RE: P.Z. 02-2024 18009 and 18045 N. Outer 40 Rd. (Gumbo Flats Properties, LLC): A request for an ordinance amendment to create a new "PI" Planned Industrial District for two parcels zoned "M3" Planned Industrial District, "NU" Non-Urban District and "PI" Planned Industrial District, and totaling 78.07 acres located on the north side of Outer 40 Road (16W310045 and 16W240041).

Planning Commission Staff Report

Petition: **P.Z. 02-2024 18009 and 18045 N. Outer 40 Rd. (Gumbo Flats Properties, LLC)**: A request for an ordinance amendment to create a new “PI” Planned Industrial District for two parcels zoned “M3” Planned Industrial District, “NU” Non-Urban District and “PI” Planned Industrial District, and totaling 78.07 acres located on the north side of Outer 40 Road (16W310045 and 16W240041)

PRELIMINARY DEVELOPMENT PLAN

Figure 9: Tree Stand Delineation

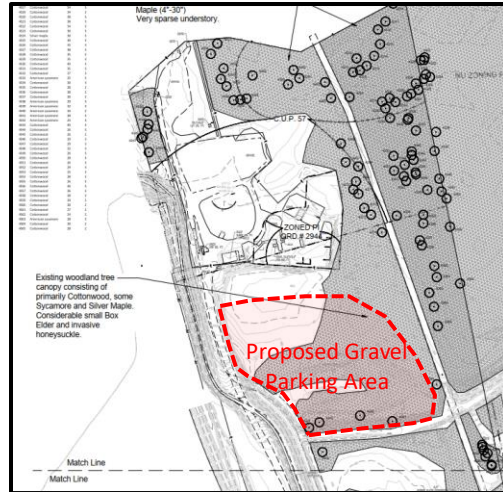
Concern was raised regarding the amount of tree removal associated with the proposed improvements. Please provide information on how the development team will be addressing this concern.

Response: Tree removal is limited, 11.6% being removed and 88.4% retained of the overall Gumbo Flats Property LLC. Assemblage.

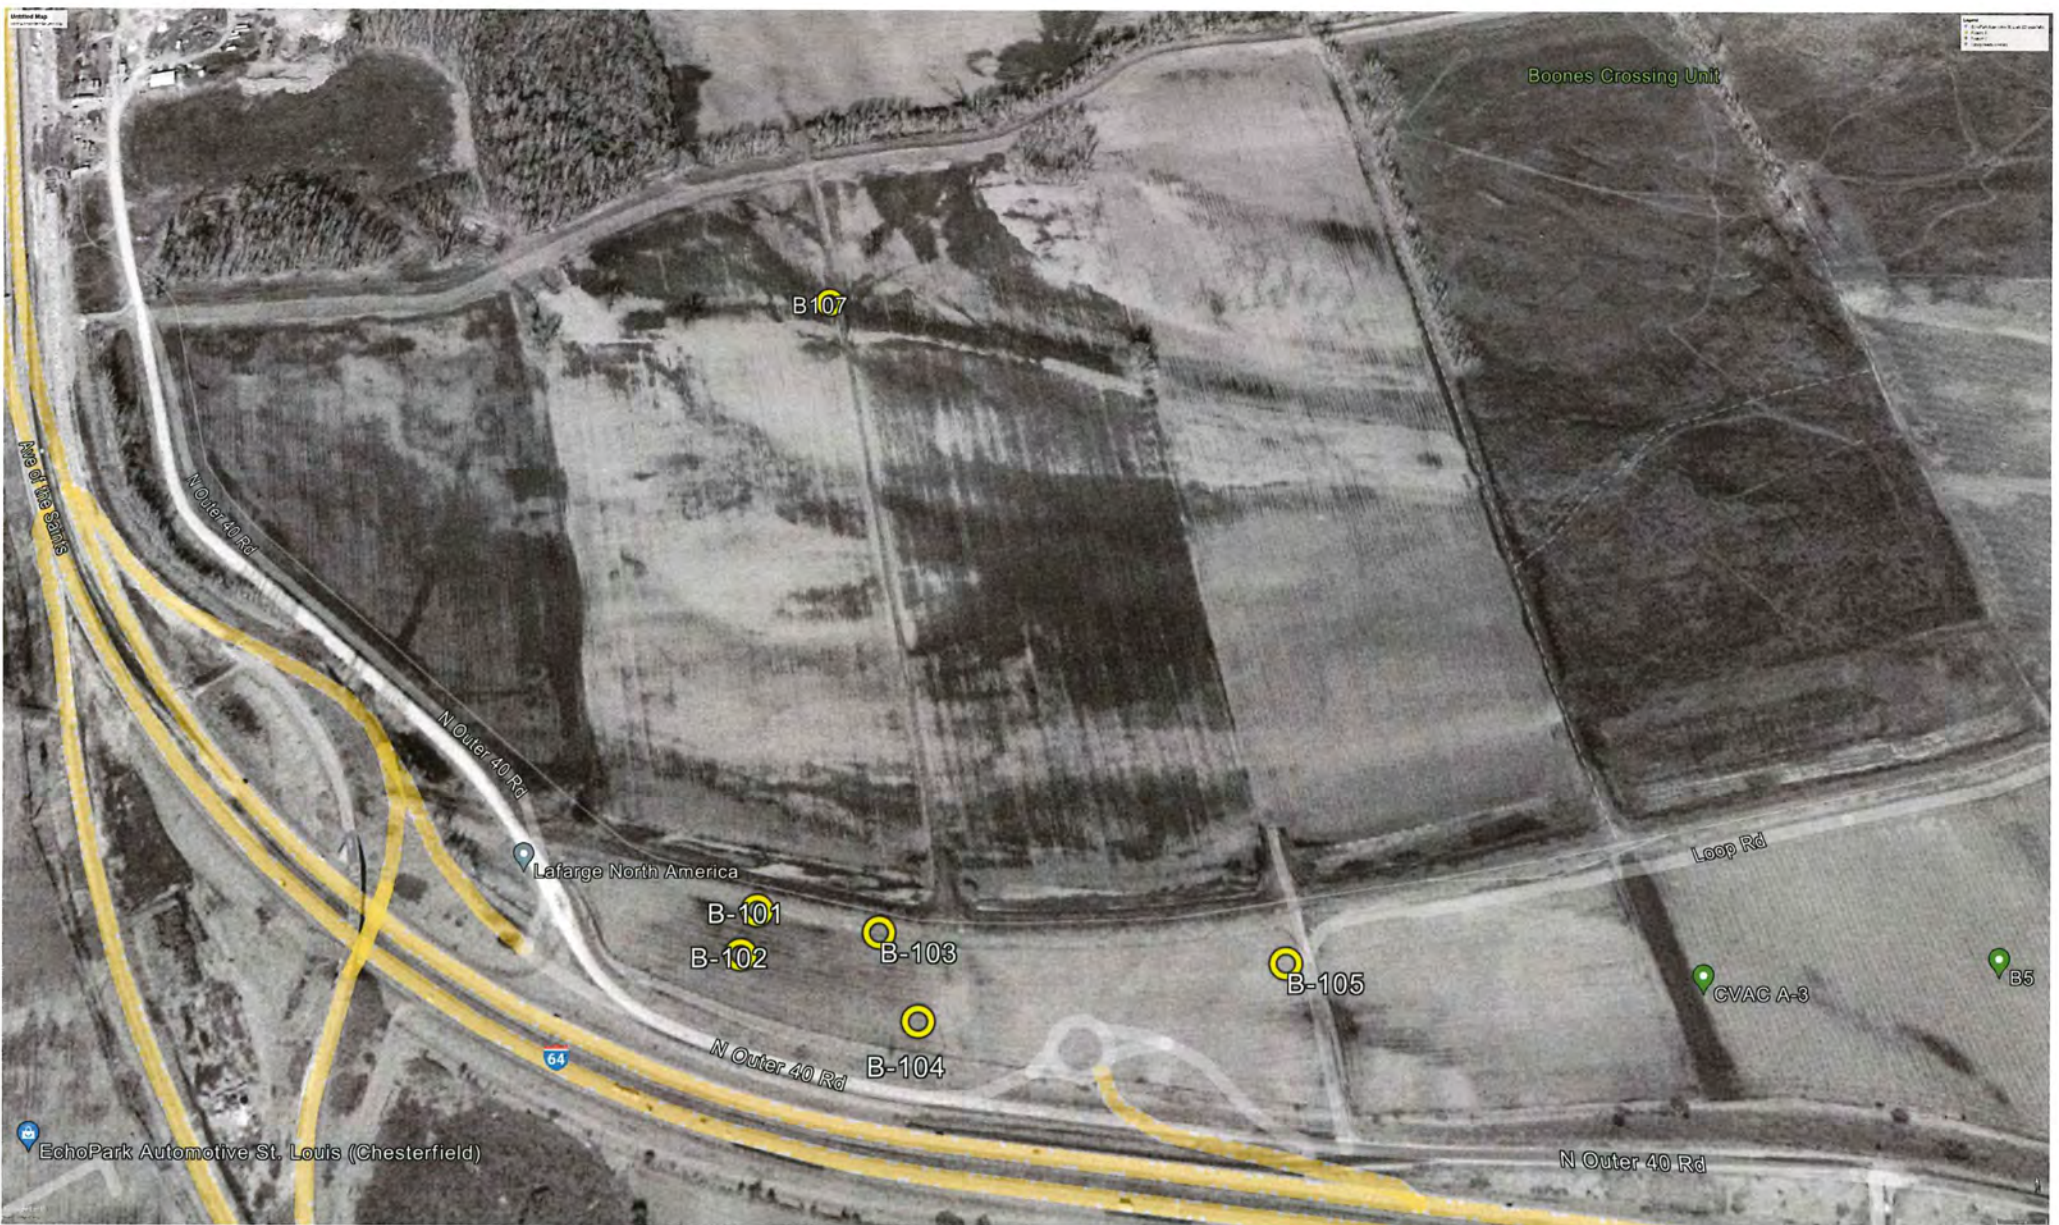
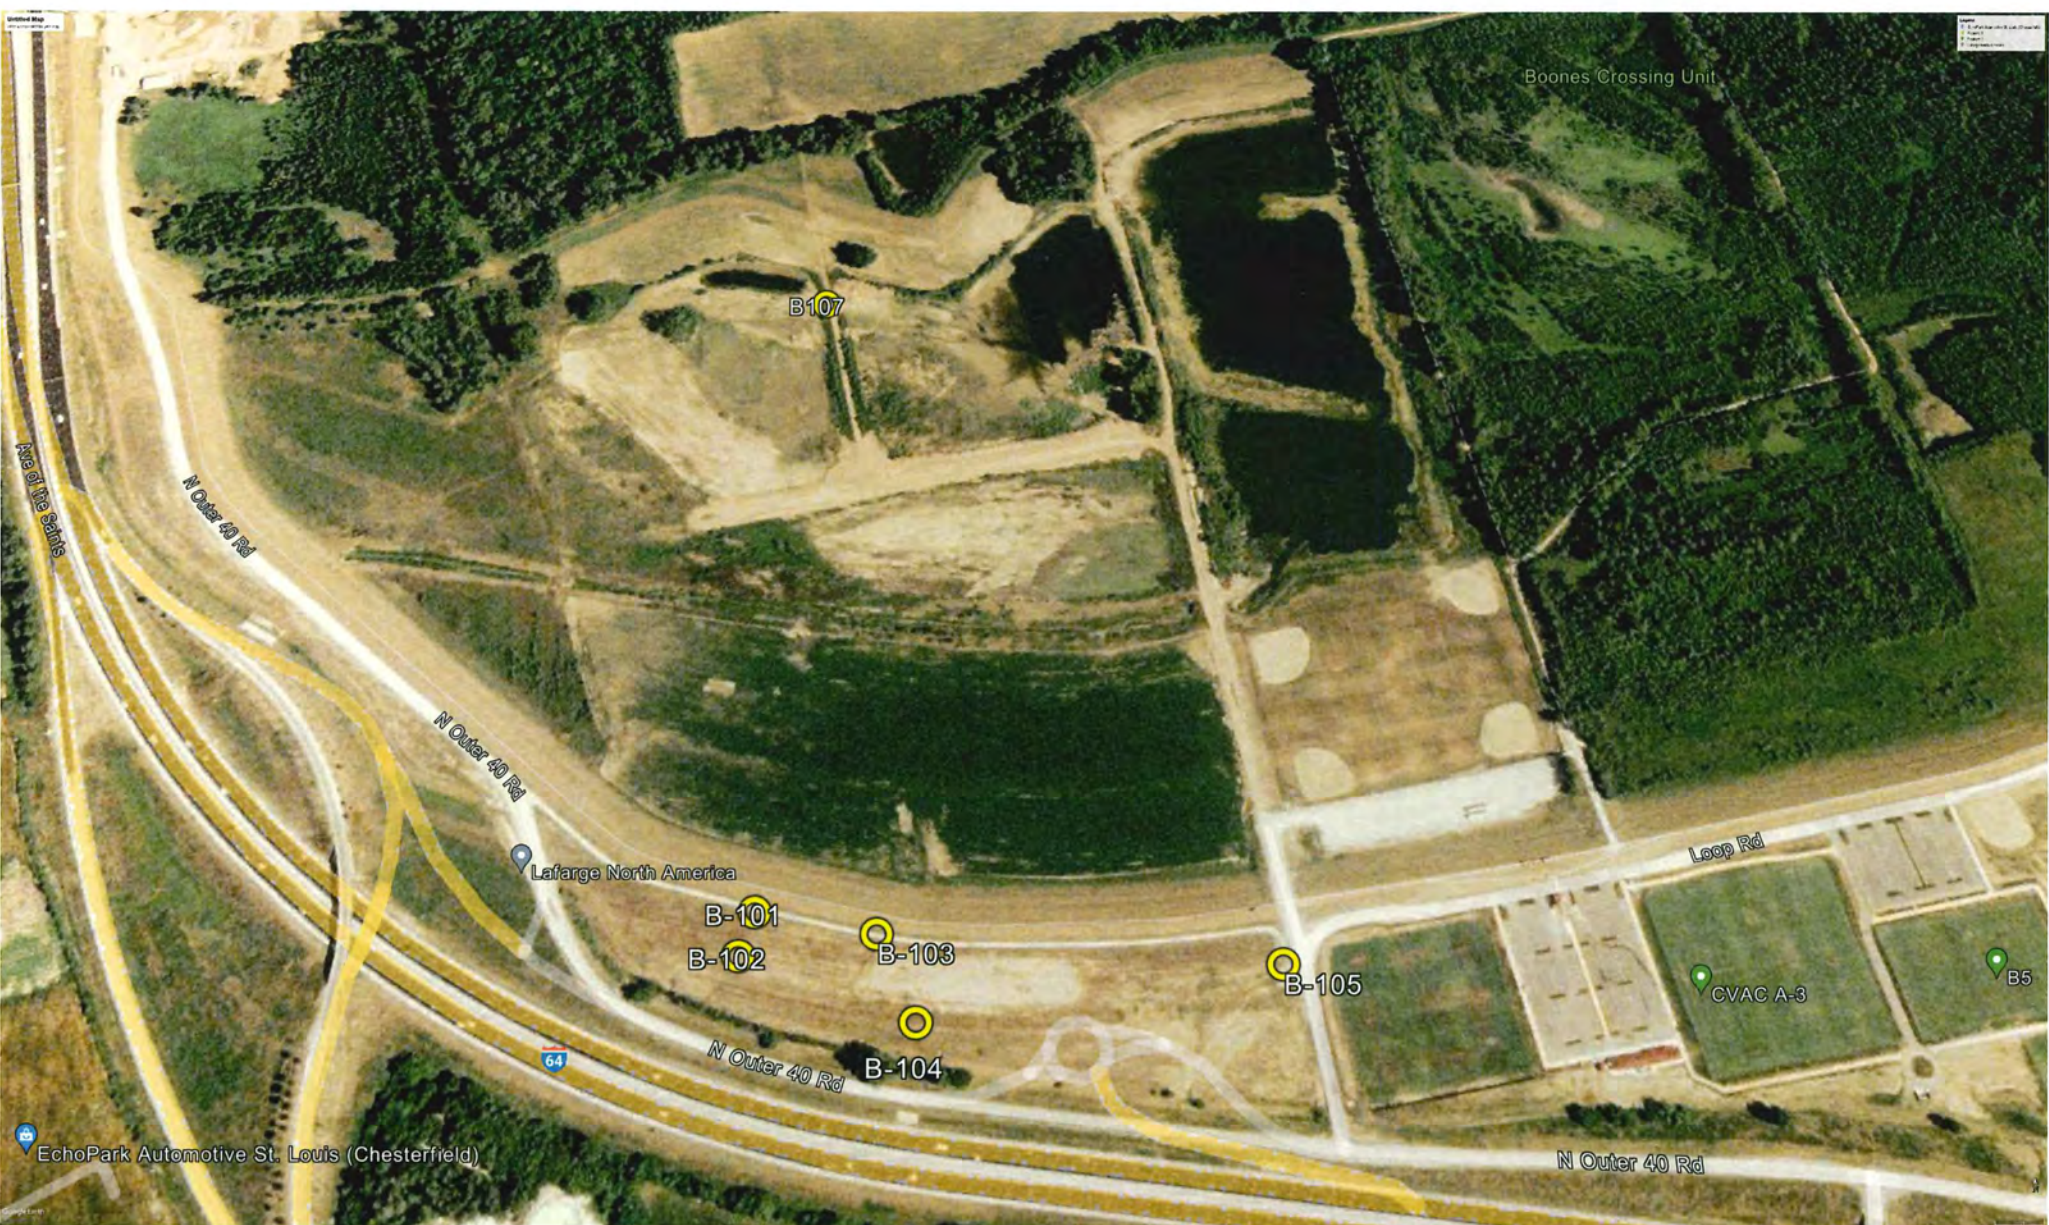
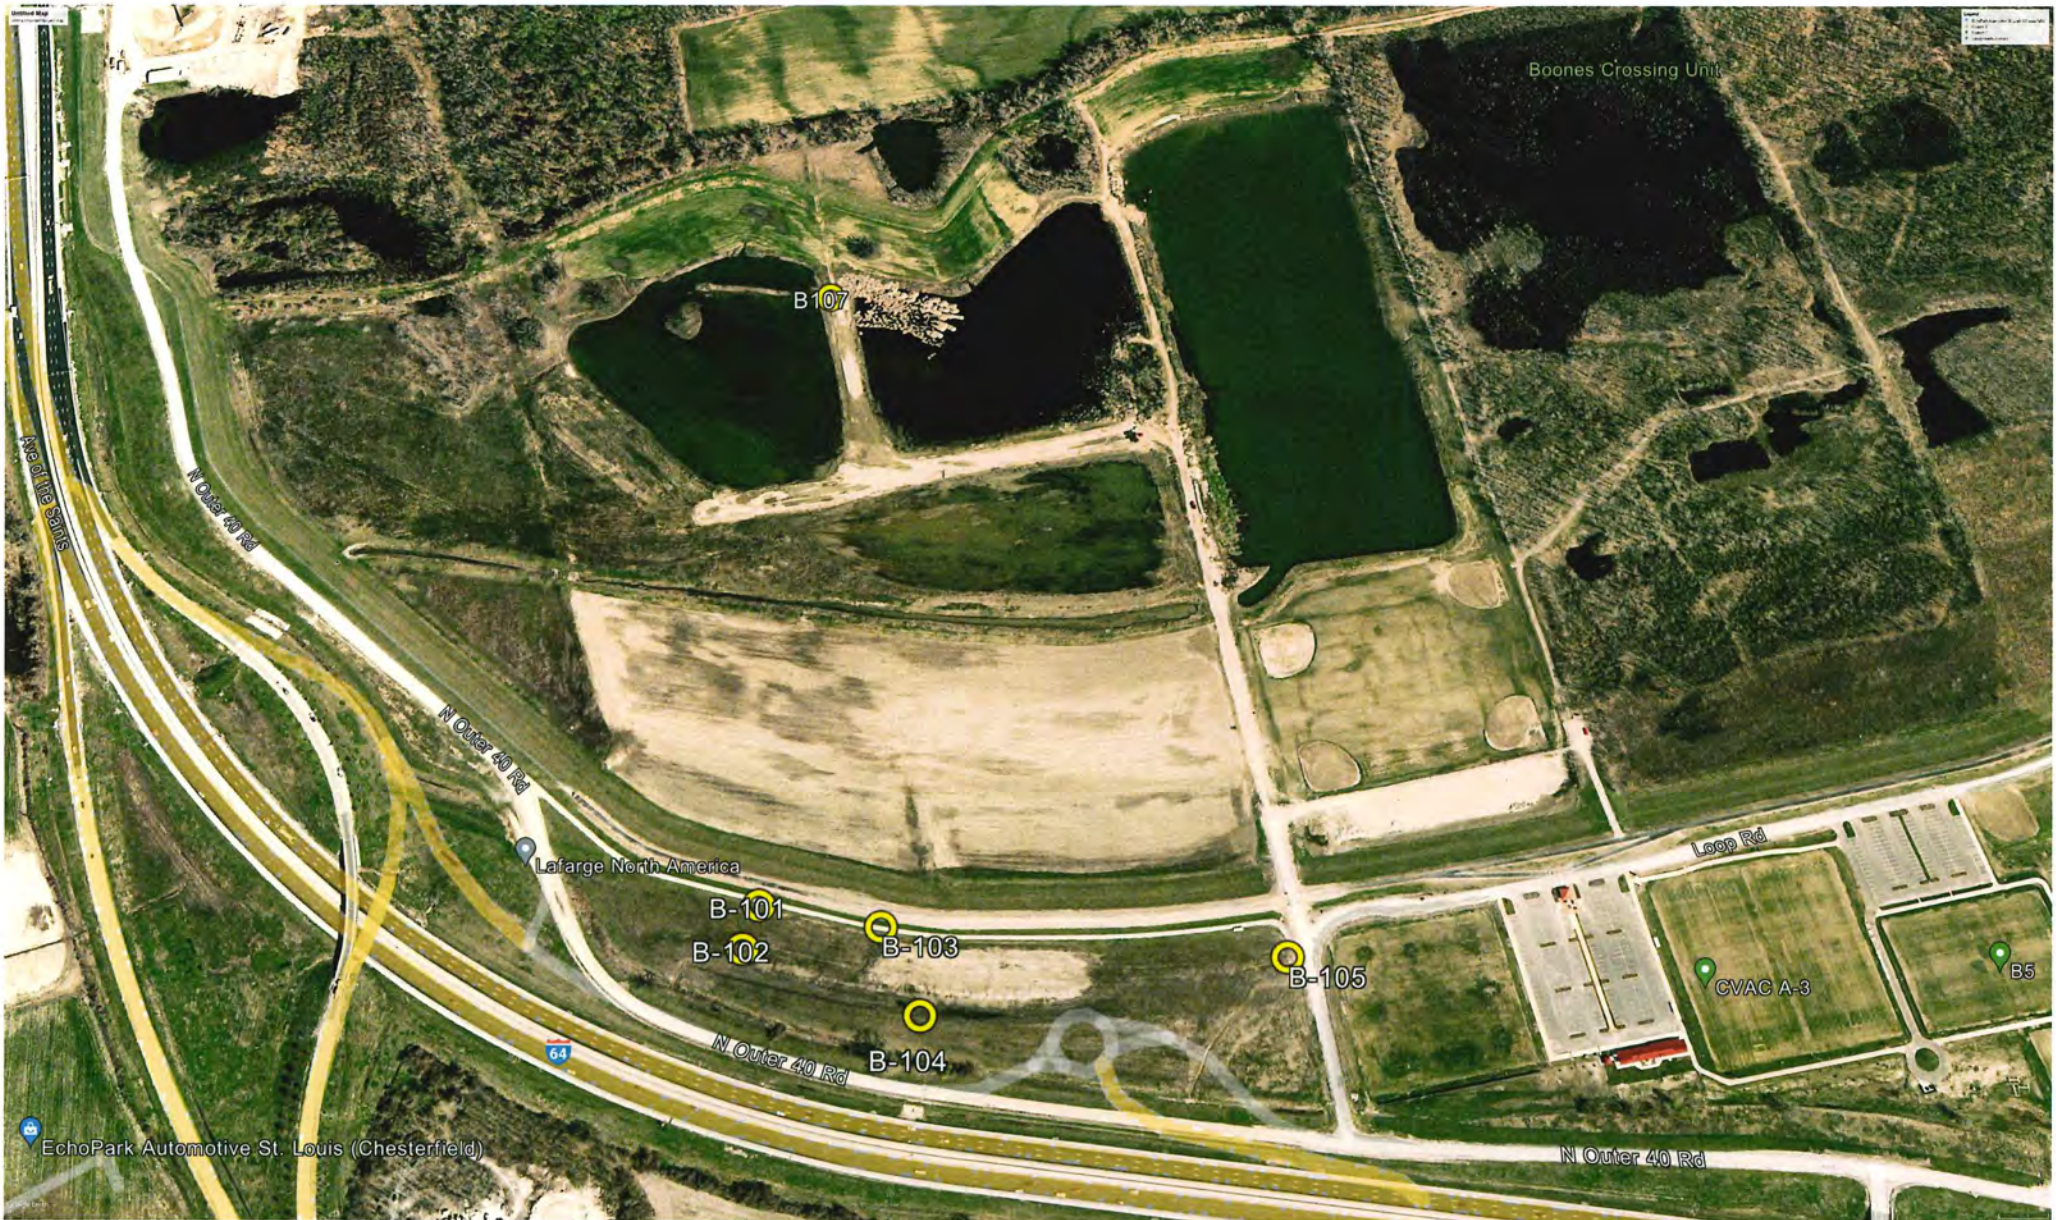
3. The City of Chesterfield Comprehensive Plan designates the subject site as "Conservation" and indicates properties within this designation should, "focus on preservation." Provide information on how the development team will have consistency with Conservation land use designation.

Response: Previous discussions with the city determined that the city's Master Plan consultant was not asked to study this property because of City and Levee district ownership at the time of the comprehensive plan. Gumbo Flats Properties LLC / Gateway Studios is enhancing the existing openspace of the land assemblage. Currently a Site Development Plan is being processed through the City demonstrating the overall enhancement and improvements to the previously disturbed areas. They are constructing passive recreational amenities for their private use where borrow pits were previously dug and illegal dumping occurred. Attached are a series of aerial photos from 1990 – 2015 illustrating farming and borrow operations.
